# SERVICE BULLETIN

### OF OIL PUMP ASSY. OR OIL PUMP SHAFT ASSY.

### ON ROTAX® ENGINE TYPE 912 A (SERIES)

### SB-912-032

Bild / Fig. 1

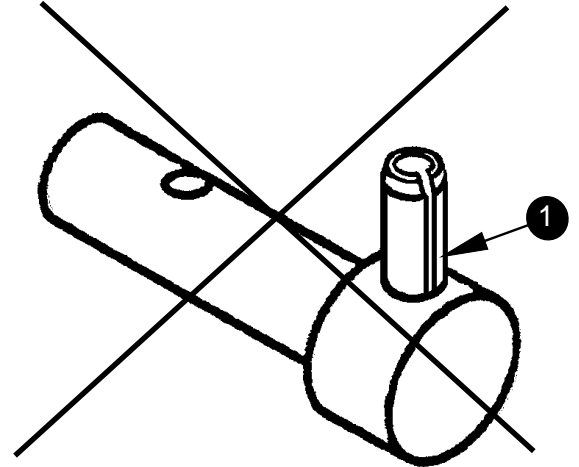
In isolated cases traces of wear on the dowel sleeve of the oil pump shaft were noticed.

- Remove oil pump.
- Inspect oil pump for proper condition.
- Remove oil pump shaft with dowel sleeve 5x28 (1) and install oil pump shaft with solid drive pin 5x26 (2) p/n 837 129.
- Install oil pump.

Ölpumpenwelle kpl. TNr. 837 129 mit eingepreßtem  
Kerbstift /  
oil pump shaft assy. p/n 837 129 with solid drive pin

Ölpumpenwelle kpl. mit Spannhülse /  
oil pump shaft assy. with dowel sleeve

◆ NOTE: The new oil pump shaft p/n 837 129 is only supplied with solid drive pin.
